DEPARTMENT OF THE ARMY  
Omaha District, Corps of Engineers  
106 South 15th Street  
Omaha, Nebraska 68102-1618

Amendment No. 0004  
4 September 2003

SUBJECT: Amendment No. 0004 to Specifications and Drawings for Construction of  
(FY03) NORTHCOM HQ BEDDOWN ADDITION, BMC, AND AT/FP IMPROVEMENTS,  
PETERSON AFB, COLORADO. Solicitation No. DACA45 03 B 0005.

TITLE:  
**EXPANSION JOINT DETAIL**

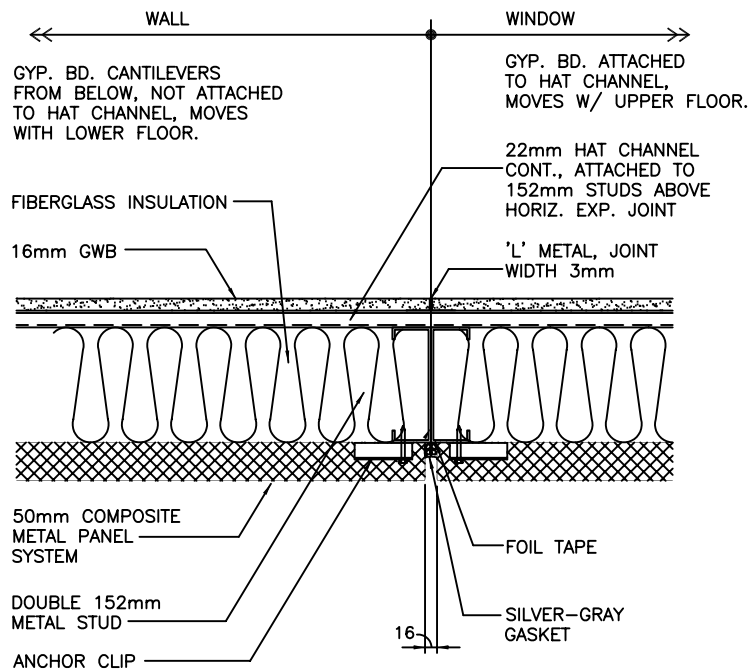
(28) **Create New Drawing A7.06** titled "TYPICAL METAL WALL PANEL DETAILS", and insert the details shown on Attached Sketches A-1, A-2 and A-3.
